Addendum #2

**Bid Opportunity: CPS-RFT-25-03 - North Paris Fire
Station**

Addendum

PROJECT: North Paris Fire Station

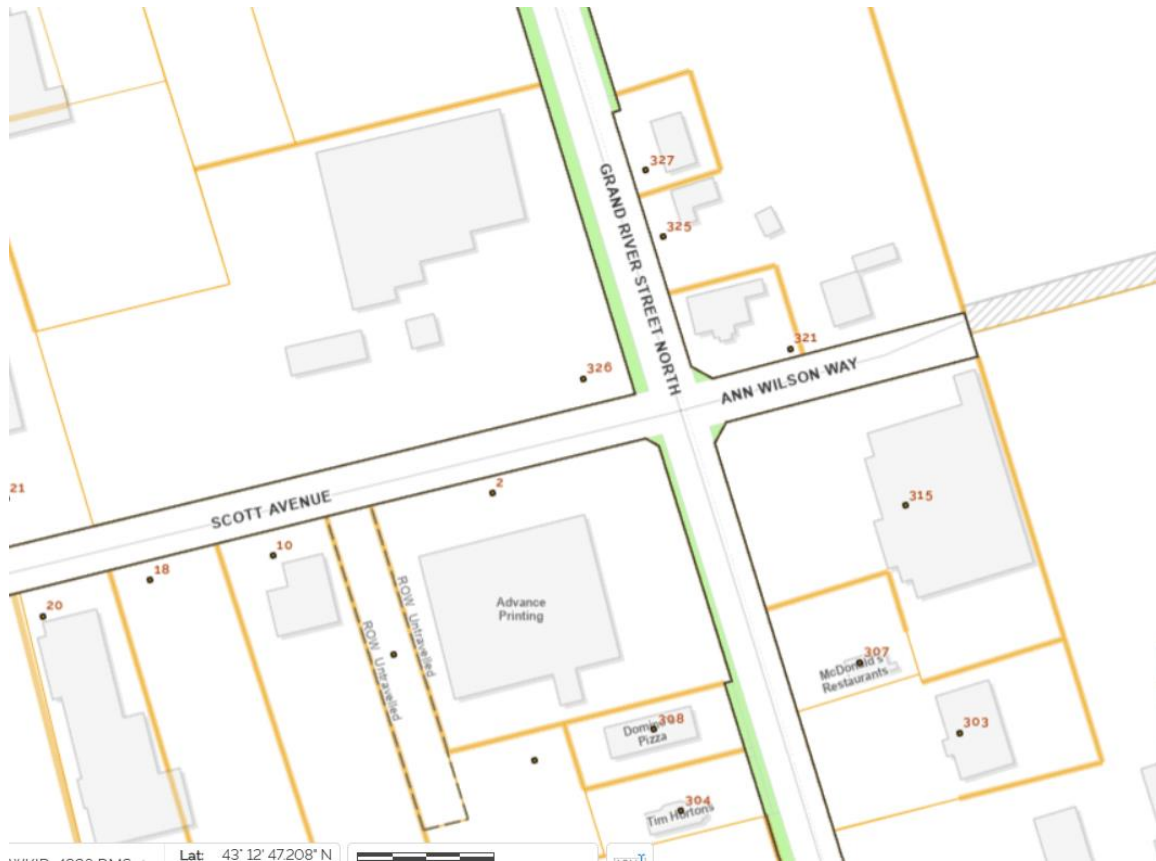
Question 9: 21 Ann Wilson way does not exist on maps. Please clarify what project address and postal code should be used for insurance/ bid bond purposes.

Answer 9: Currently on google maps, the location can be located on Scott Avenue on the East side of Grand River Street North. This section of road has been renamed 21 Ann Wilson Way. Currently, there is no postal code assigned. Please see updated County of Brant internal map below.
